City of Providence Zoning Board of Review
Application for a Dimensional Variance Amendment #1
280 Melrose Street
Providence, Rhode Island

GZA Job No. 05.0045179.00

July 1, 2021

The Narragansett Electric Company d/b/a National Grid submits this amendment to its City of Providence Zoning Board of Review Application for a Dimensional Variance to revise its request for relief from the exterior lighting requirements. Figure LL-101 has been revised and is attached. Appendix A Application for Variances, Number 8 Paragraph 2 and 3 has been revised and the revised text is below.

LL-101

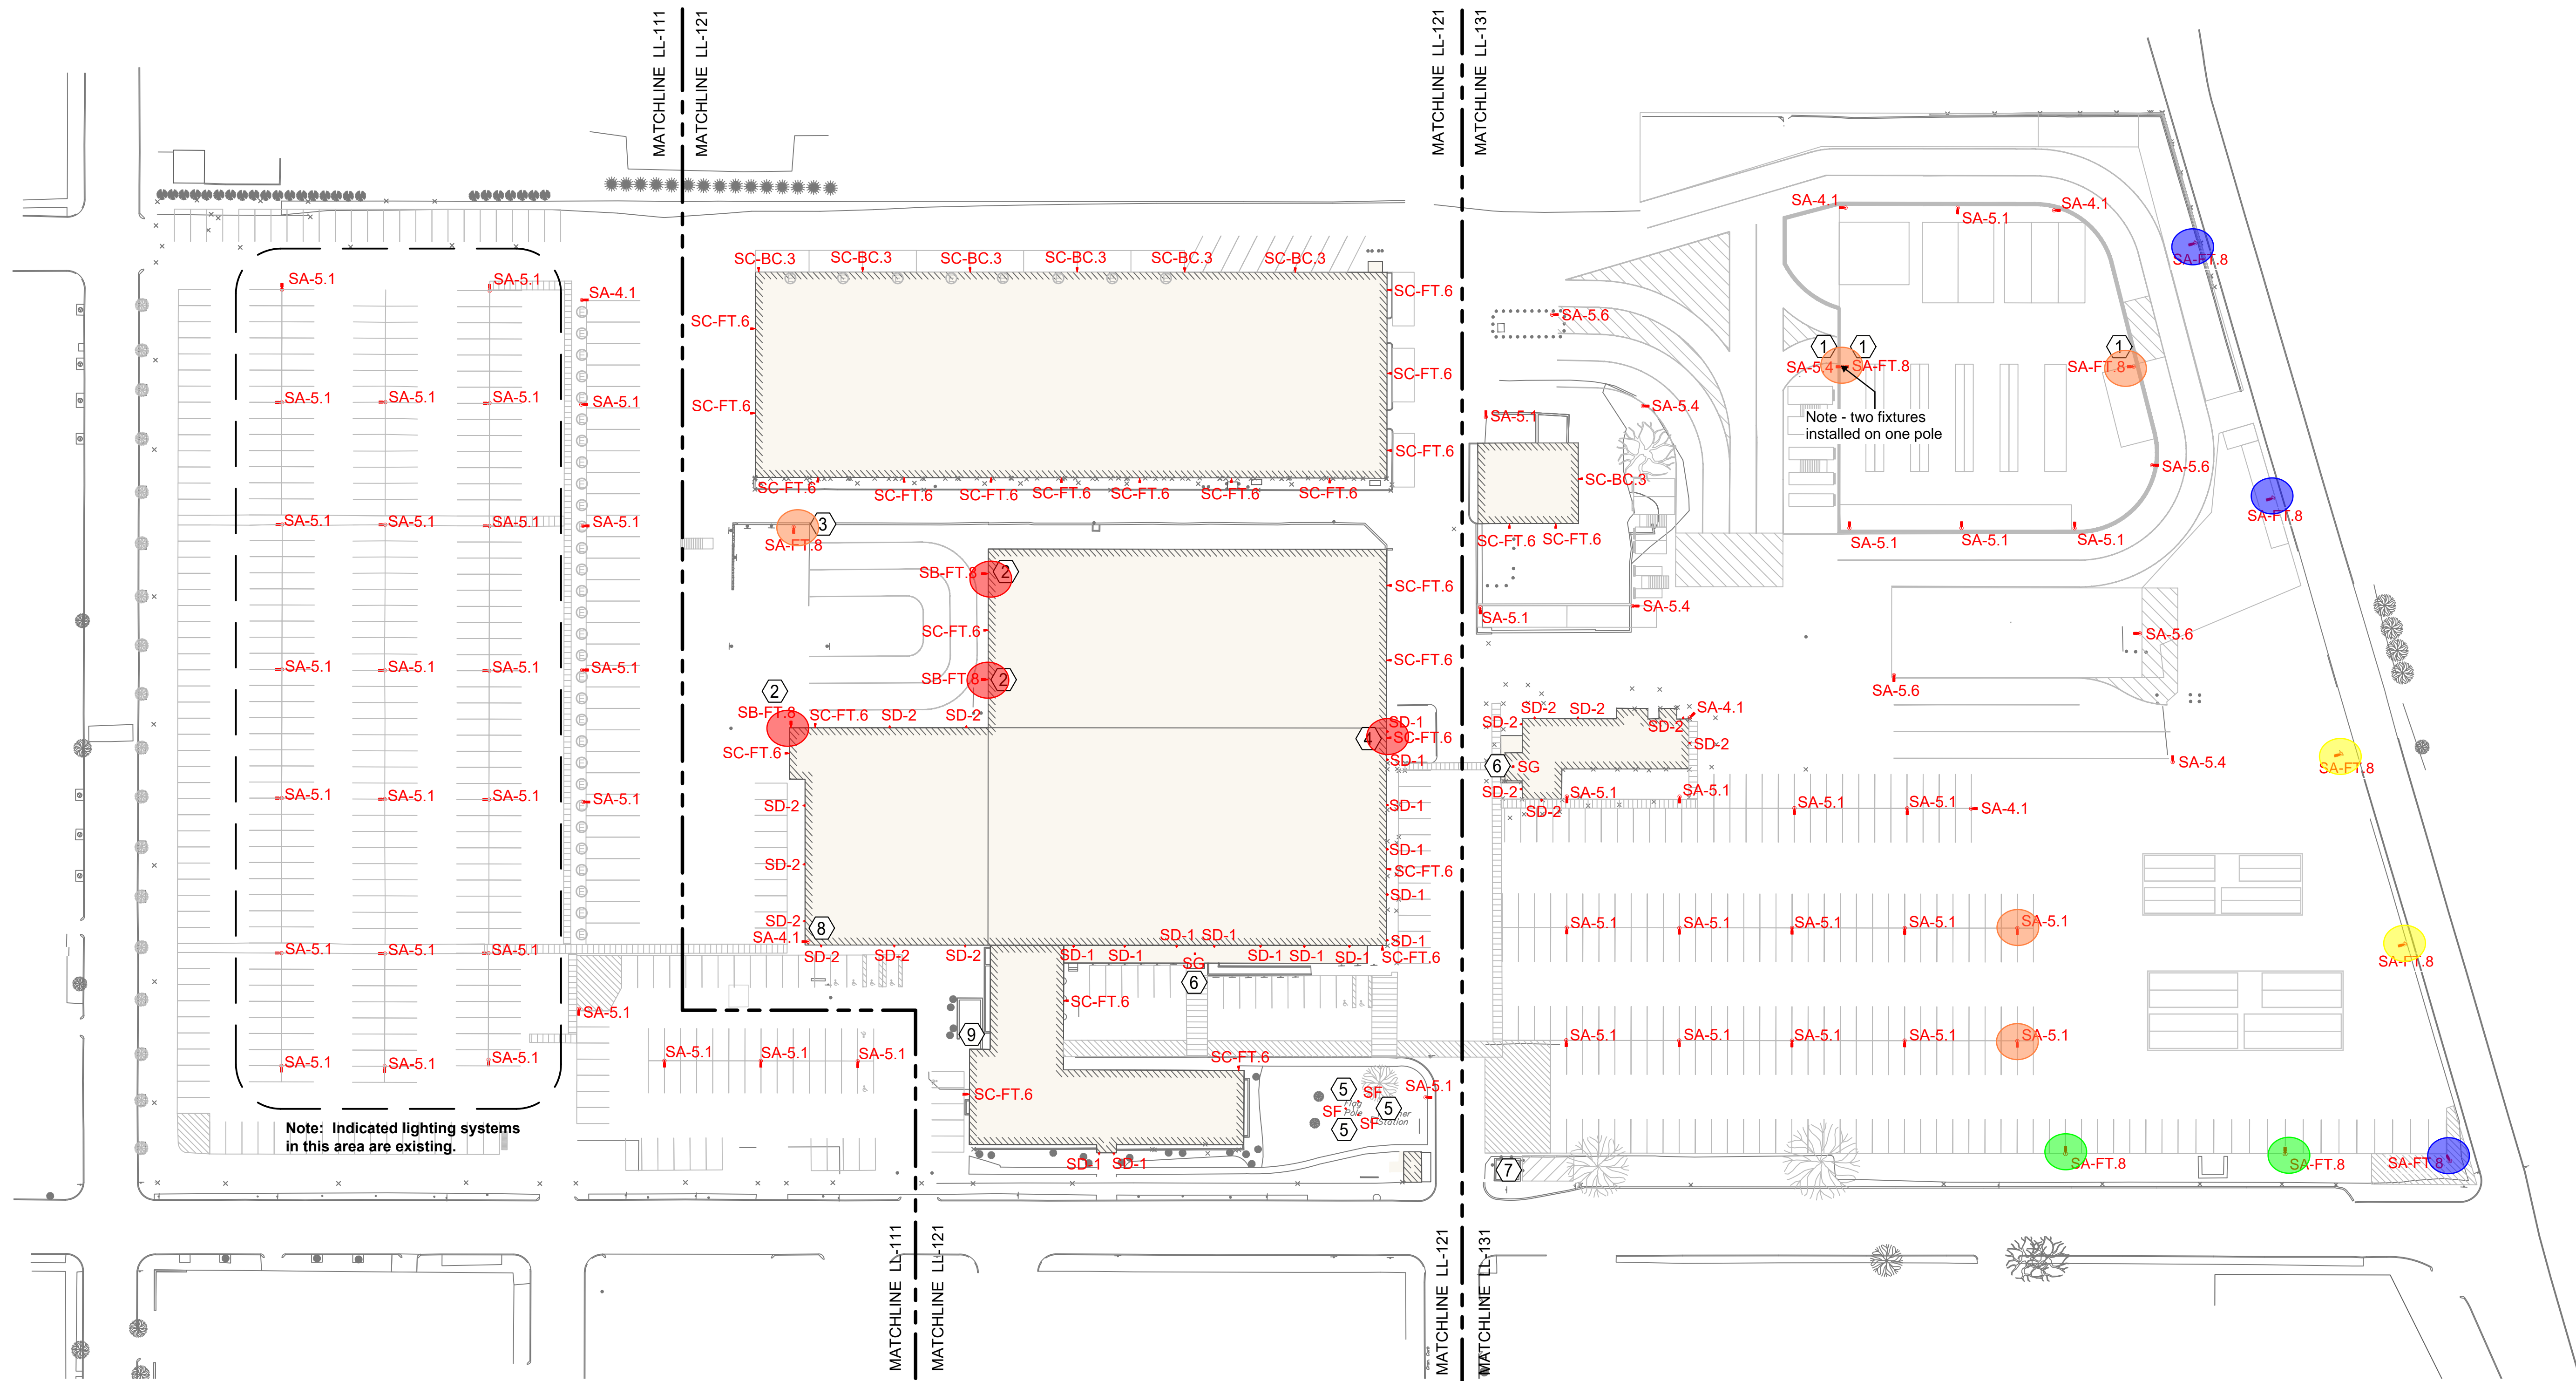
1. Four (4) out of a total of sixty-seven (67) building mounted fixtures will remain at a non-conforming height of approximately 30 to 35 feet above the ground surface (above an existing fire escape and garage doors).

2. Thirteen (13) out of a total of fifty-one (51) pole mounted light fixtures will remain non-conforming for the following reasons:
 - a. Three (3) pole mounted fixtures on the Property along Cadillac Drive with non-conforming fixtures and street lights (owned by the City of Providence) will remain non-conforming because light levels will be greater than one foot-candle at property line. These poles cannot be relocated because of the existing street lights and aerial hazards associated with use of the area (equipment and utility pole storage).

- b. Two (2) pole mounted fixtures on the Property along Cadillac Drive with non-conforming fixtures and street lights (owned by the City of Providence) will be replaced at a non-conforming height of 35 feet above ground surface with light levels at the property line will be greater than one-foot candle. These poles cannot be relocated because of the existing street lights and aerial hazards associated with use of the area (utility pole storage).

- c. Two (2) pole mounted fixtures on the Property along Melrose Street will remain non-conforming because light levels will be greater than one-foot candle at the property line. These poles cannot be relocated because of the aerial hazards associated with use of the area (utility pole storage).

- d. Six (6) pole mounted fixtures on the Property within the outdoor storage yard will be installed at non-conforming heights of 30 to 35 feet.

The total number of non-conforming fixtures on the site will decrease by thirteen (13). All proposed exterior lighting is designed as cut off LED luminaires. The maximum foot-candle at any lot line will be less than one-foot candle with the exception of the five (5) replacement lights along Cadillac Drive and two (2) replacement lights along Melrose Street necessary to light a portion of the outdoor storage yard. Exterior lighting (including select non-conforming features) is necessary in order to maintain a secure, safe and well-lit parking lot, outdoor storage yard and vehicle operations facility. Employees access the outdoor storage yard 24 hours per day (in all weather conditions) and it must remain well-lit for safety and security purposes.
